STATE OF DELAWARE
EXECUTIVE DEPARTMENT
OFFICE OF MANAGEMENT AND BUDGET
Budget Development, Planning and Administration
State Planning Coordination

RE: 2009-09-02; Family Foundation Academy Addition

According to the information received, you are seeking site plan approval for an additional 73,157 sq. ft. to be added to the existing Family Foundation Academy.

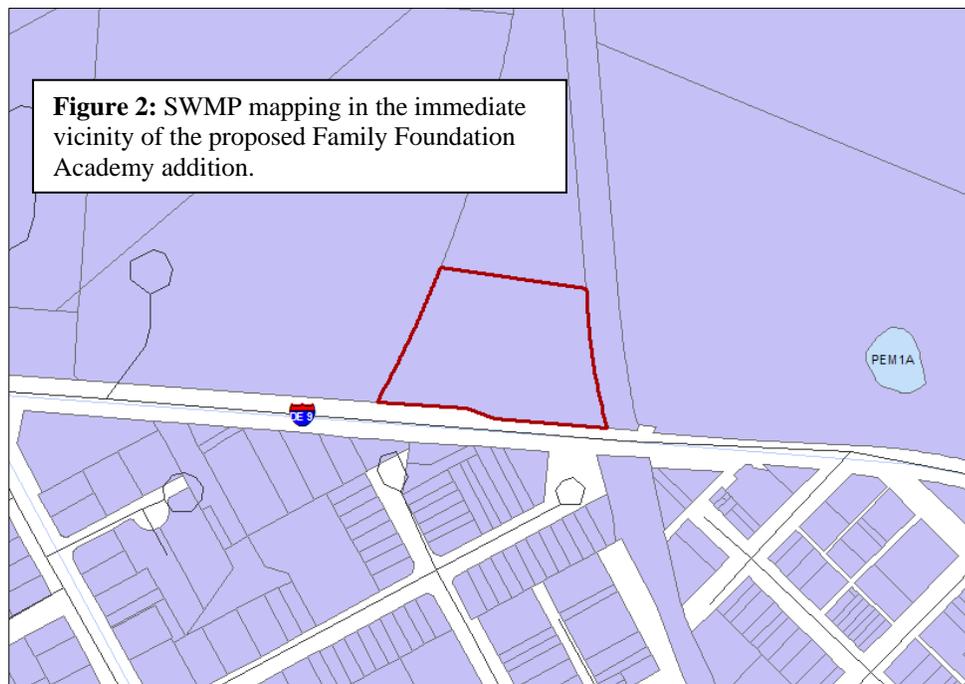
Soils Assessment. According to the New Castle County soil survey, Othello (Ot) was mapped over the entire parcel. Othello is a poorly-drained wetland associated (hydric) soil that has severe limitations for development and should be avoided (Figure 1).
